**1316 Crotty #11 – Modernization**

**End of Addendum 1**

A502

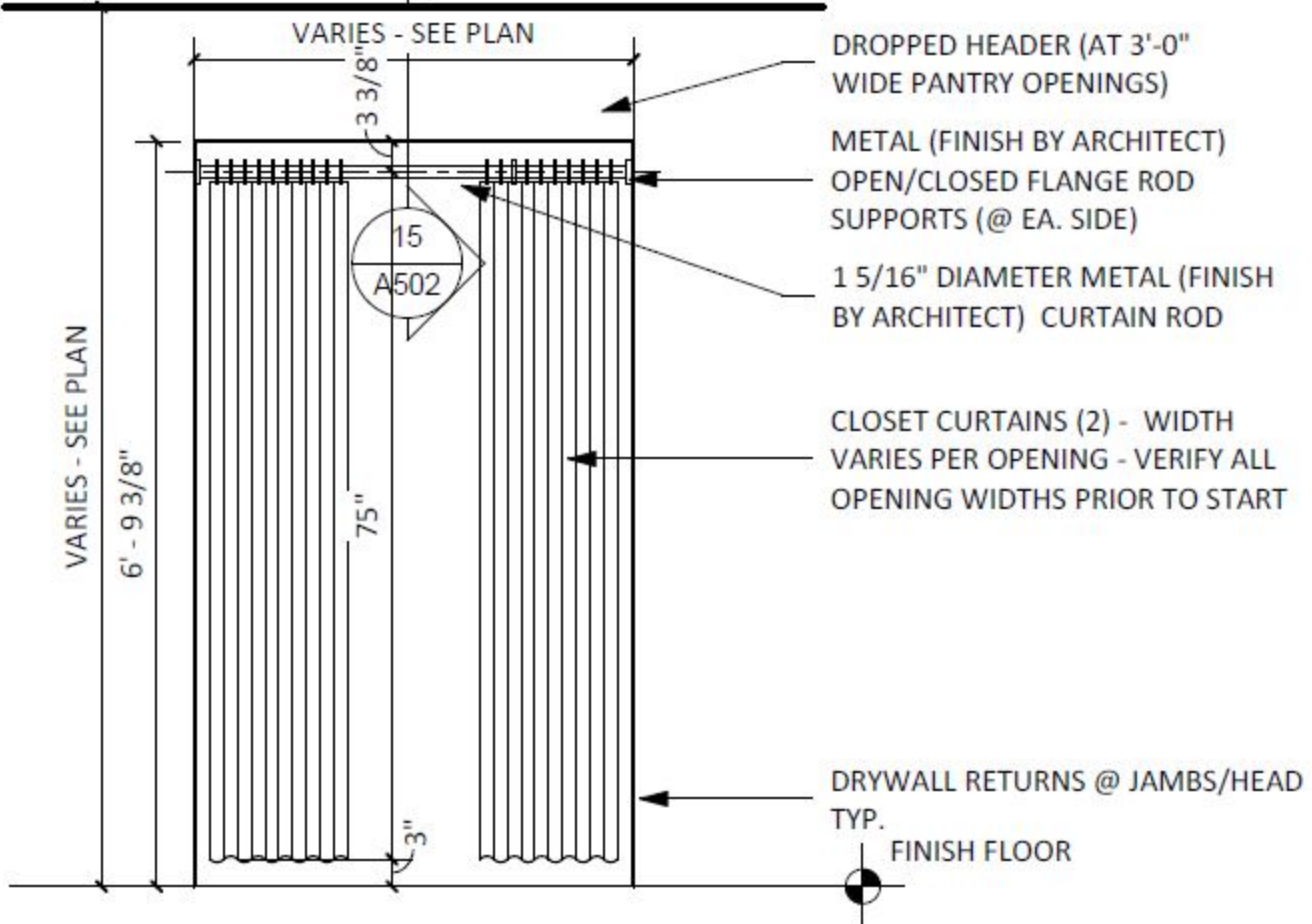
1. **Clarification:** The textured walls must be smoothed out to a level 4 finish prior to painting.
2. **Clarification:** The VCT floor must be removed prior to installing tile in bathroom.
3. **Clarification:** Contractor responsible for all plumbing modification needed to install tub, sinks, and toilet.
4. **Clarification:** The closet door shall be a curtain rod and curtains. See detail attached. Curtains shall be 2 panel. Each panel is to be at least ½ the width of the closet opening. Selectblinds, New Modern Farmhouse Curtains, Harvest Beige, Ivory liner, Nickel grommets.
5. The pre-quote walk thru sign in sheet is attached.
